**Addendum No. 1**  
**February 17, 2025**

Project: Lincoln High School Auditorium Renovation  
Sioux Falls, South Dakota  
Project #3021

Architect: Architecture Incorporated

Sheet Contents **UPPER FLOOR PLAN - LIGHTING**

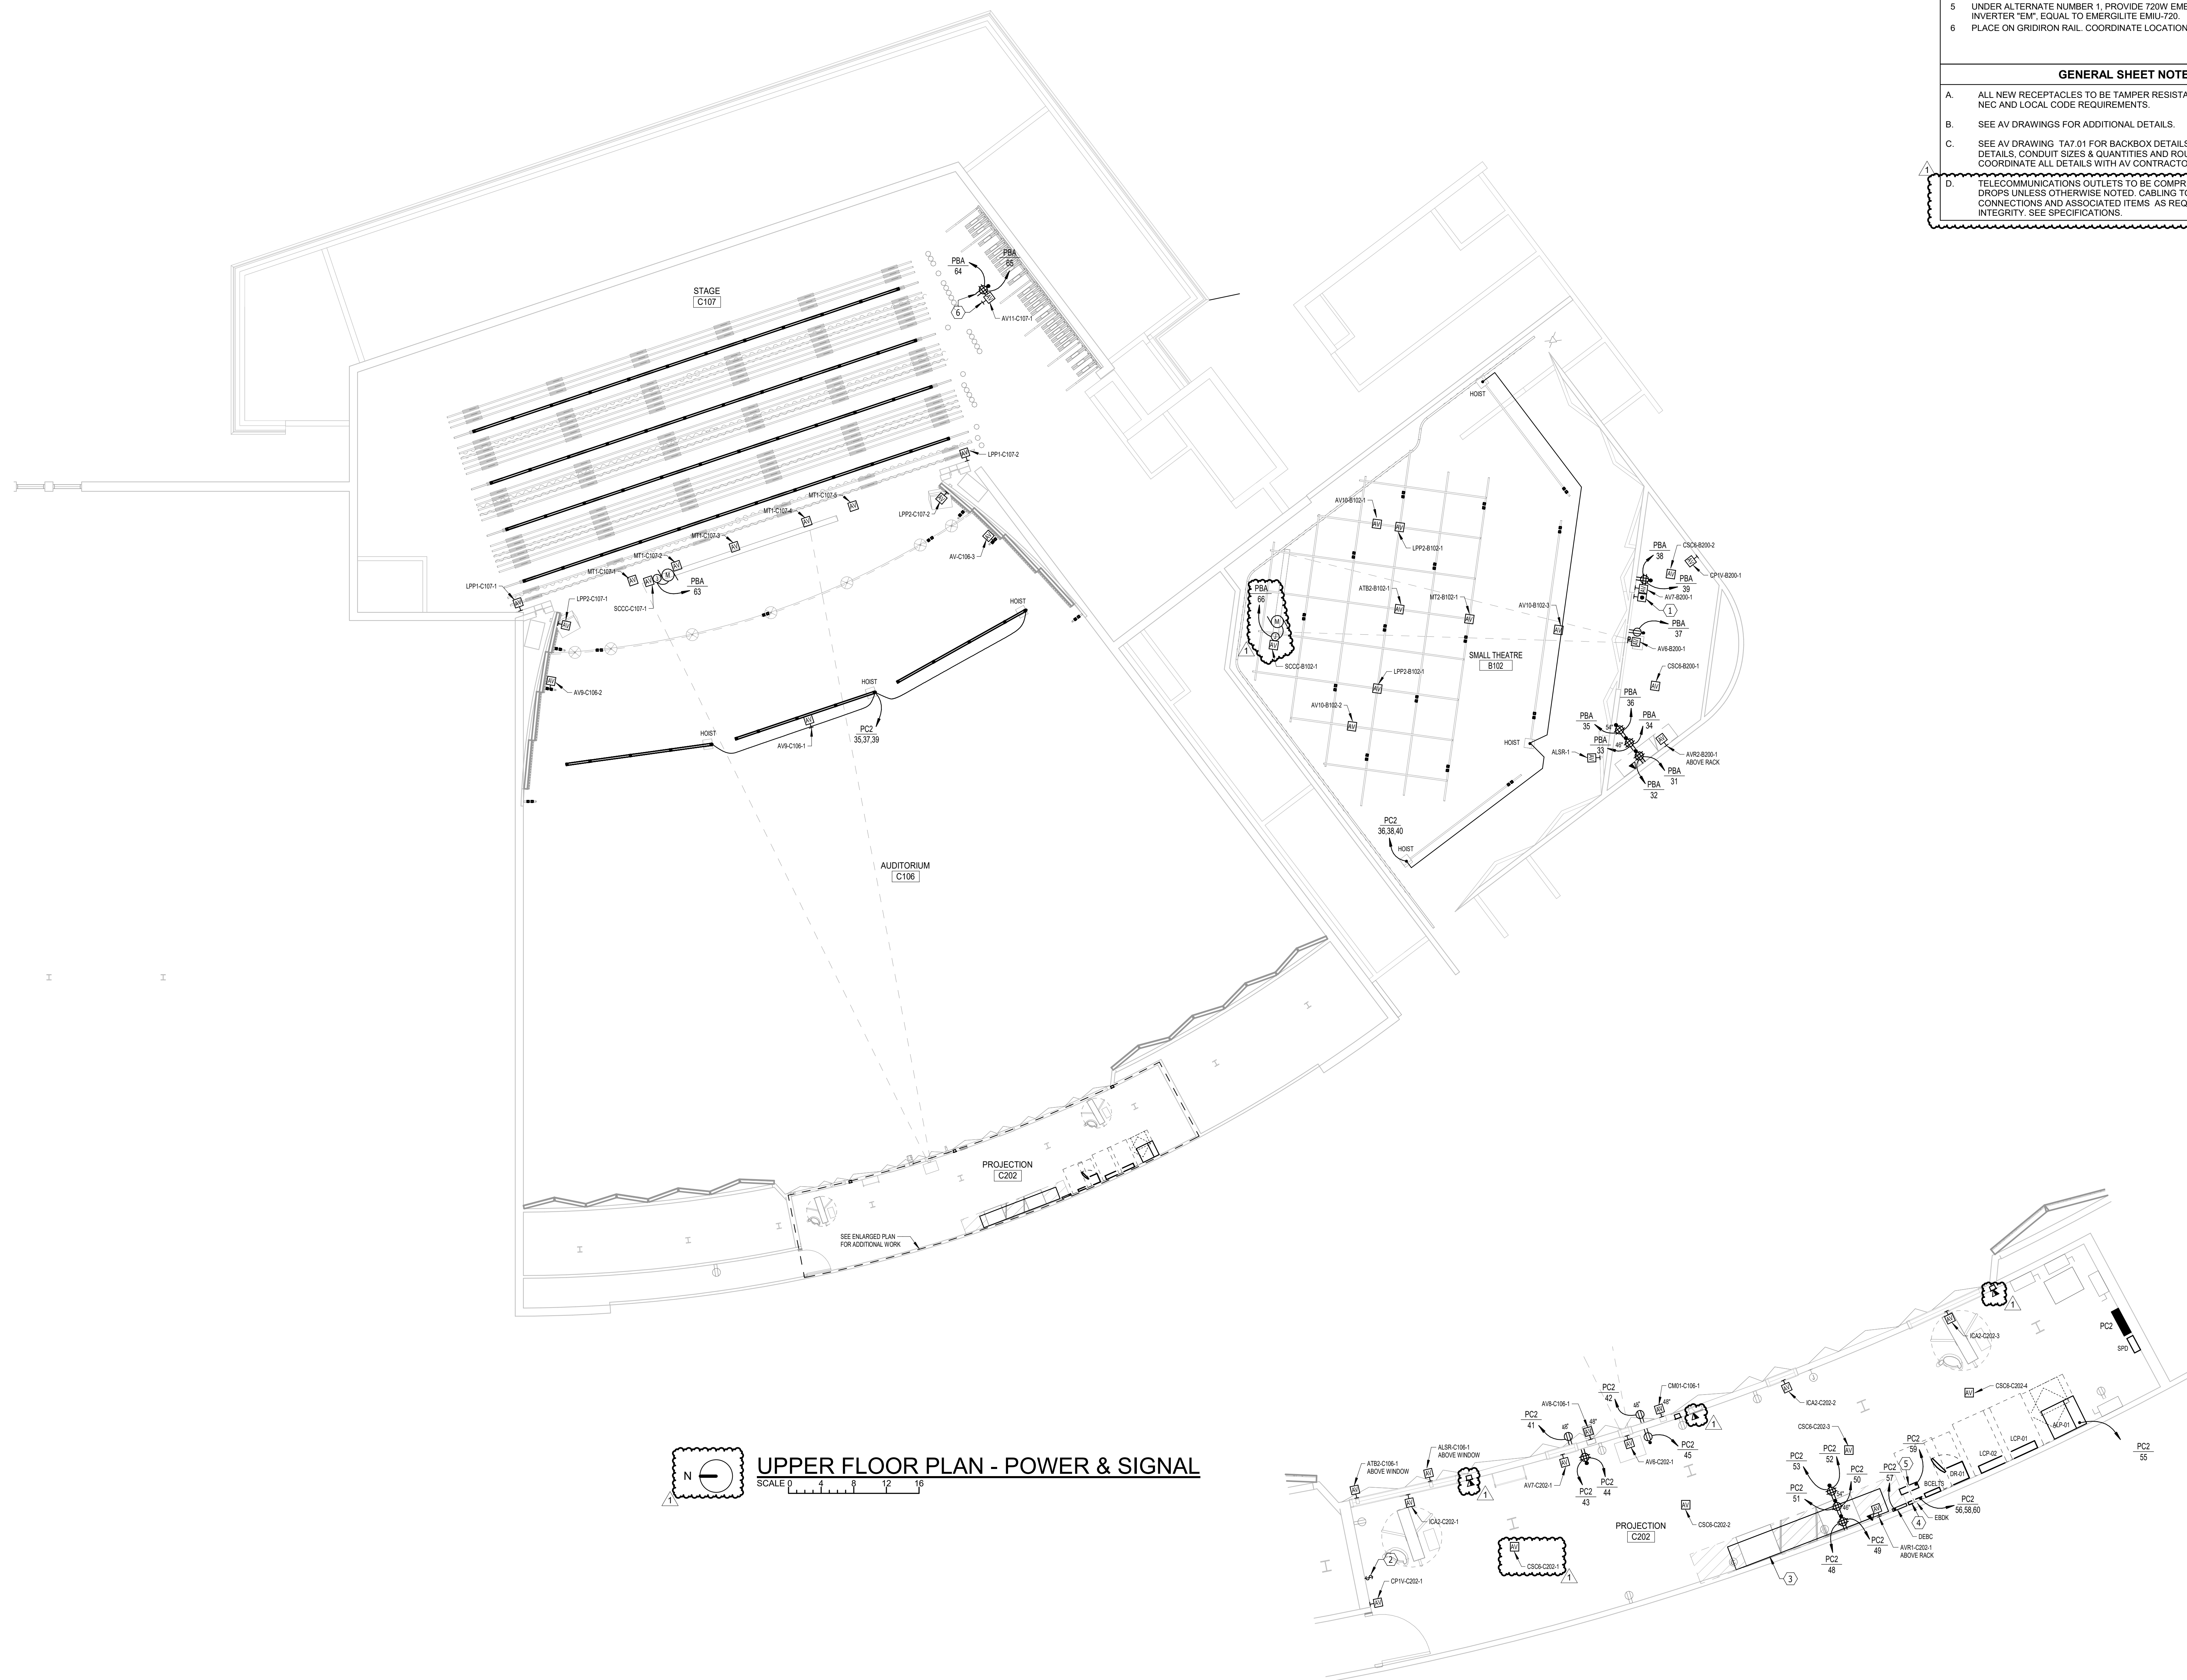
- 6) SHEET 9.32 – UPPER FLOOR PLAN – LIGHTING
  - a) Reference the attached drawing sheet, revision dated 2-17-25, for miscellaneous modifications.
- 7) SHEET 9.33 – UPPER FLOOR PLAN – POWER & SIGNAL
